SAFETY BULLETIN

COALTRAM® CT08 AND CT10

Transmission cover not latched securely leading to injury

Ref Document No.	SB13001	Issue No.	1
Release Date	04 April 2013

Figure 1. Modified latch details

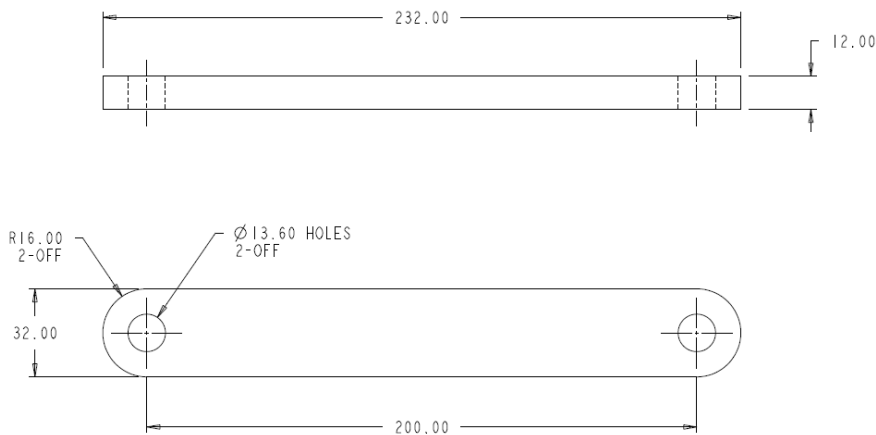
It was revealed that when the alternator cover is raised and latched in position, the transmission cover is able to rise past vertical and rest against the alternator cover however cannot be securely latched in place.

In order to unlatch, either of these covers, they must first be taken past the vertical position and then lowered. In this particular incident, both covers were open, the alternator cover latched and the transmission cover resting against it. The alternator cover was then moved in order to be closed, which required it being taken past the vertical position. Subsequently the transmission cover which was resting on the alternator cover was moved past its vertical axis and fell closed. This action caused the fingers of an adjacent worker to be struck and an injury was sustained.

It is recommended to shorten the transmission cover latch (Part No. 5575701153) by 50mm in order to allow the cover to be securely latched when the alternator cover is in the open position. This will enable personnel to correctly latch the cover in the open as it removes the need to travel over centre. Refer Figure 1 below for details of modified latch.
